# CITY OF ALBUQUERQUE

March 4, 2022

**RE: 1424 Riverview Dr NW**  
**Grading and Drainage Plan**  
**Engineer's Stamp Date: 02/23/22**  
**Hydrology File: J11D044**

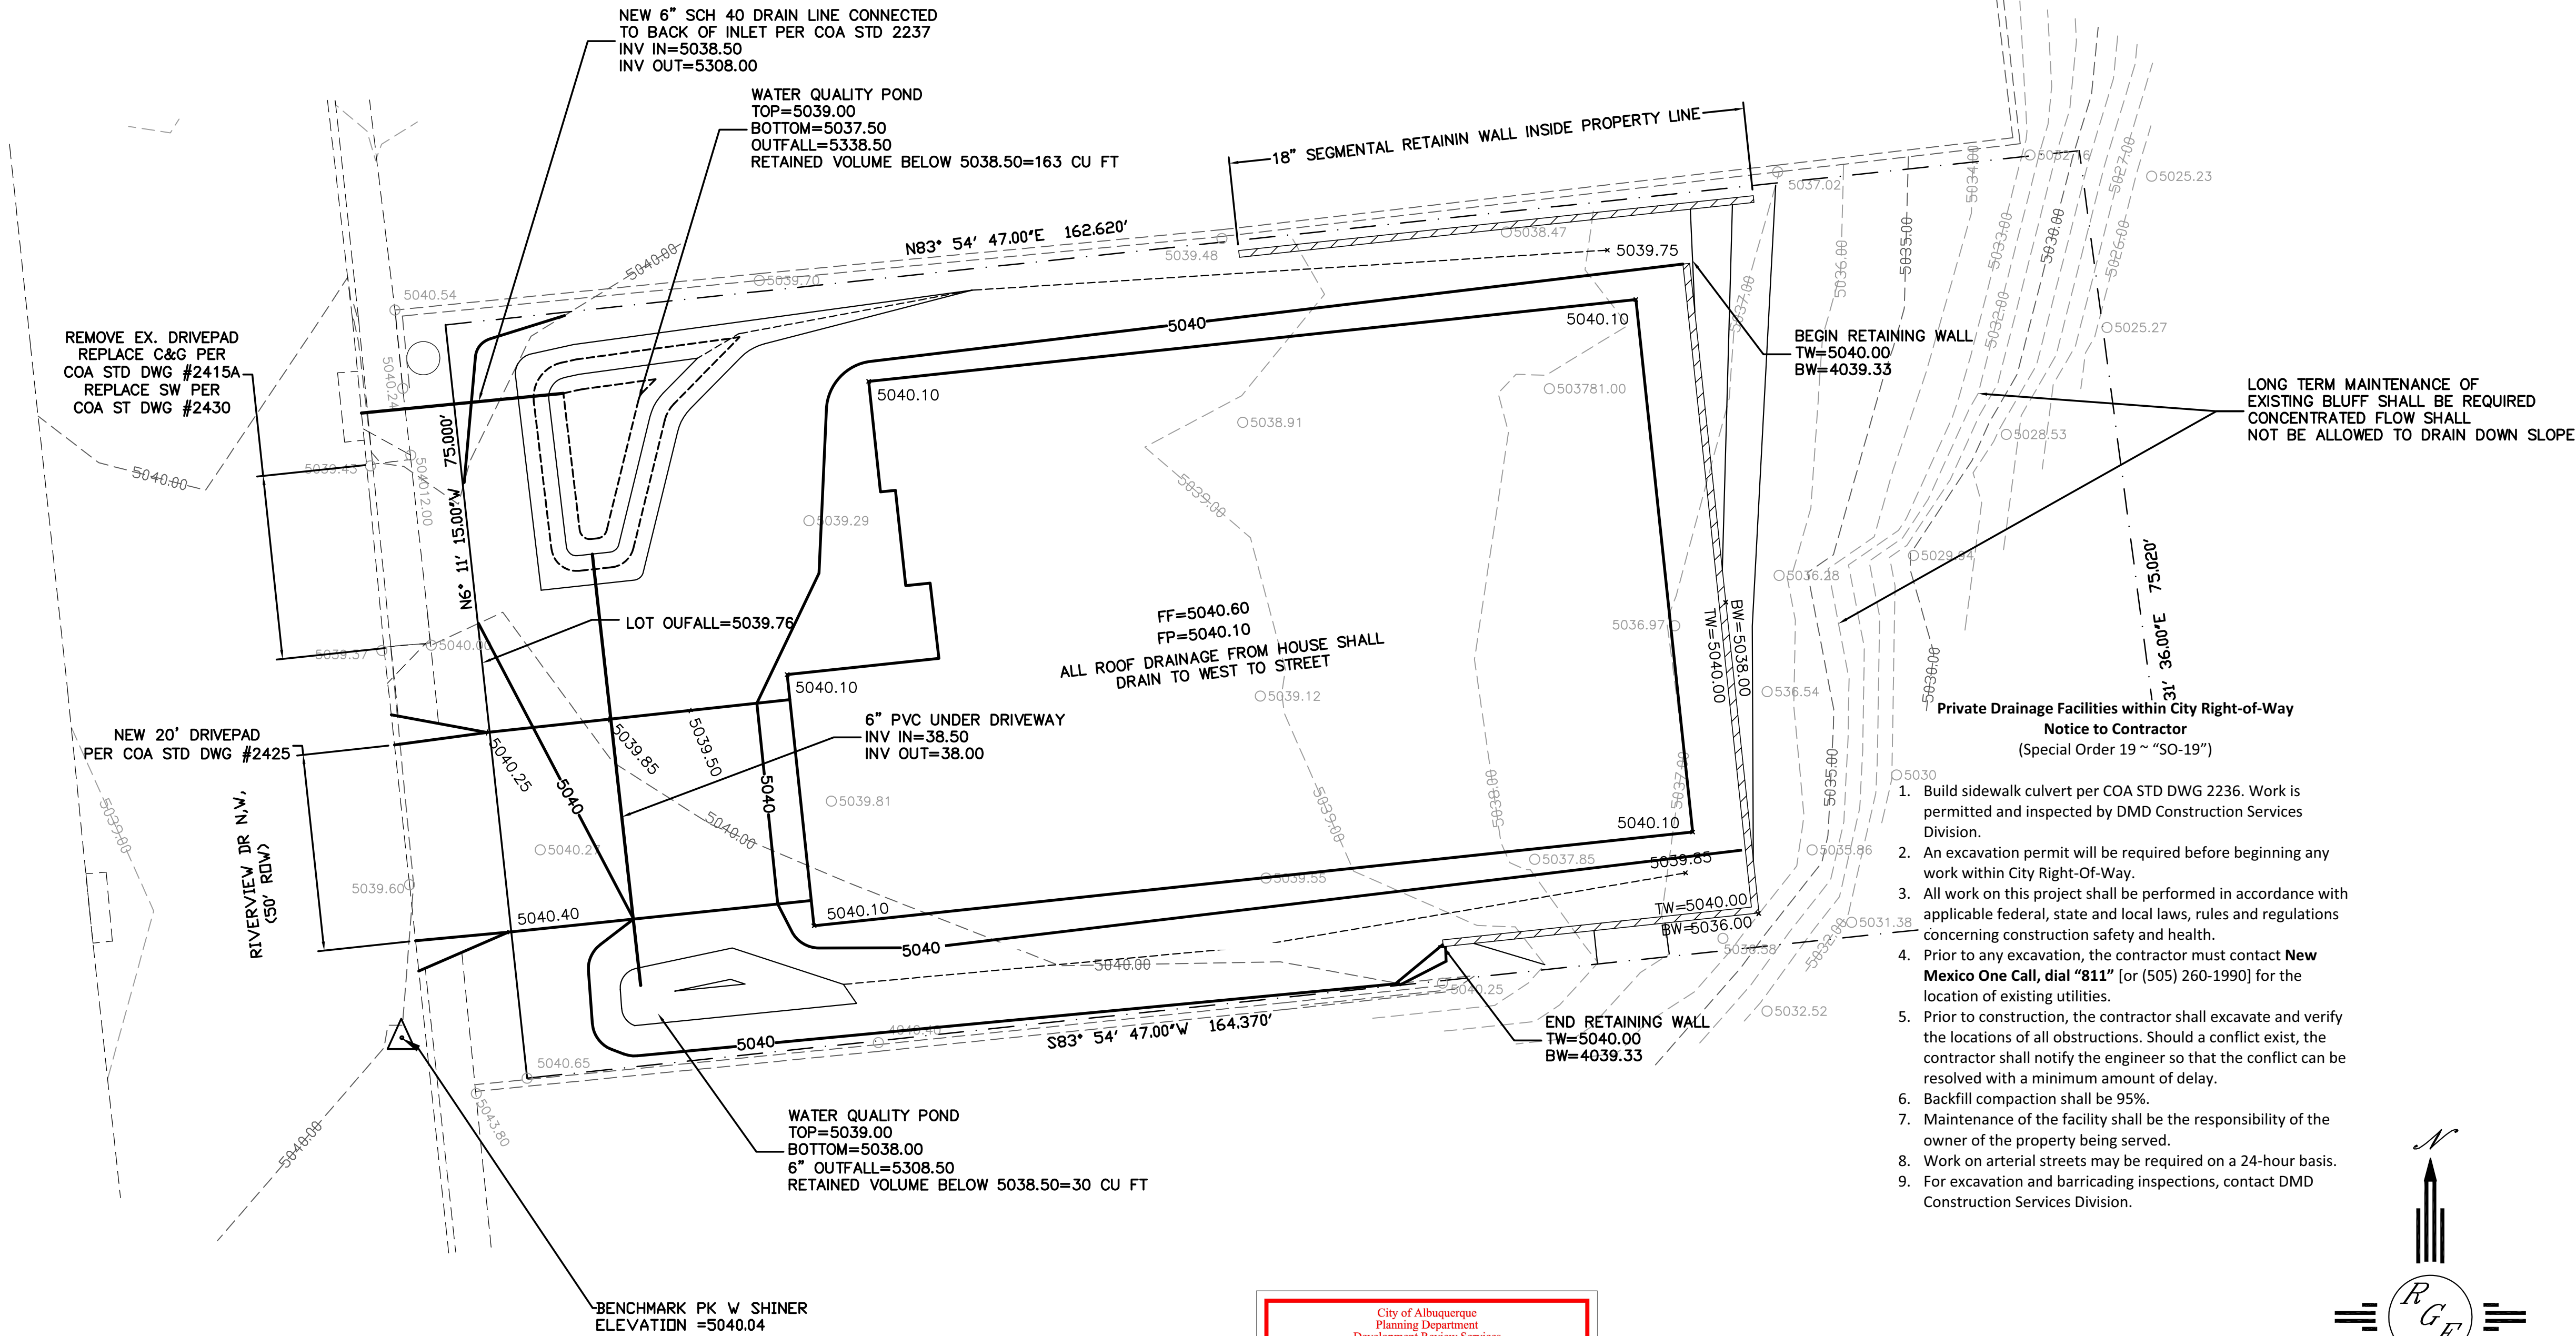
Based upon the information provided in your submittal received 02/23/2022, the Grading and Drainage Plan is approved for Building Permit, Grading Permit, and SO-19 Permit. Since this site currently is relatively flat except the rear of the lot, a pad certification is not needed for this project. Please attach a copy of this approved plan in the construction sets for Building Permit processing along with a copy of this letter.

1. Engineer's Certification, per the DPM Part 6-14 (F): Engineer's Certification Checklist For Non-Subdivision is required.
